From: [Buddie, Matthew](#)
To: [Alan Goldich](#)
Subject: RE: FW: Gravel Pit in the floodplain
Date: Thursday, June 18, 2020 3:46:54 PM

I am working on the renewal of a Special Use Permit for a gravel pit located at the confluence of Trout Creek and the Yampa River. Attached is an aerial of the pit with the floodplain mapping laid over it along with a site plan of the pit. The original pit is on the east side of Trout Creek. When this portion of the pit was permitted (2001), this area was not mapped by FEMA. Revised maps were adopted in 2005. That mapping is reflected on the attached map. In 2009 the County approved an expansion of the pit to the east side of Trout Creek. During that review, floodplains were not taken into consideration. As part of this renewal, a Floodplain Development permit will be required. I have not reviewed a Floodplain Development permit for a gravel pit before so I wanted to get some feedback on what I should be looking for. Below is what I believe needs to be addressed in the application. Please let me know if I'm missing anything.

Figure 3: Examples of NFIP-compliant homes in Zone A where the top of the lowest floor is located above the BFE

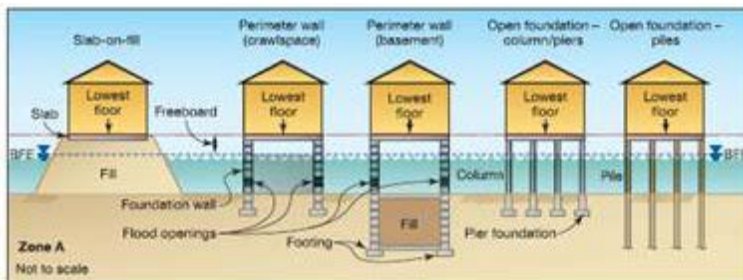
1. Scale house – do the county's regulations allow for floodproofing of non-residential structures? I only ask because you specifically say it needs to be elevated to meet elevation standards but then ask if a floodproofing cert should be required so I'm confused. If the regulations say the lowest floor must be elevated above BFE then I would say it must meet that requirement. Here are options for elevating:

If the county's regulations allow for floodproofing of non-residential structures, which I assume they do, I recommend following the guidance in:

Any option that involves floodproofing would need a floodproofing certificate by engineer/architect to show compliance.
